6.7L DIESEL ENGINE—RUNS ROUGH/MISFIRE DURING EXHAUST REGENERATION PROCESS

TSB 13-5-17

2011-2013 F-Super Duty

This article supersedes TSB 13-5-9 to update the Part List.

Figure 1 - Article 13-5-17

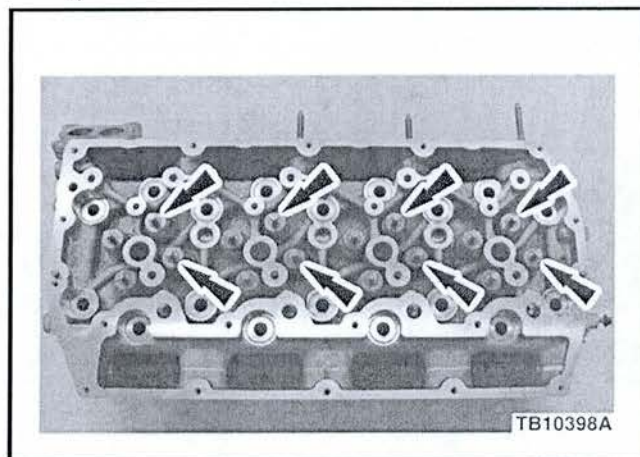
1. Did the customer indicate the message center displayed a Cleaning Exhaust Filter message prior to the concern?
 - a. Yes - proceed to Step 2.
 - b. No - this article does not apply. Refer to the Powertrain Control/Emissions Diagnosis (PC/ED) manual for normal diagnosis.
2. Using Integrated Diagnostic System (IDS) or equivalent, retrieve DTCs from the Powertrain Control Module. Are DTC's present?
 - a. Yes - this article does not apply. Refer to the PC/ED manual for normal diagnosis.
 - b. No - proceed to Step 3.
3. Remove the left hand cylinder head. Refer to Workshop Manual (WSM), Section 303-01.
4. Replace all eight (8) exhaust valves and valve seals. Refer to WSM, Section 303-01. (Figure 1)
5. Install cylinder head. Refer to WSM, Section 303-01.
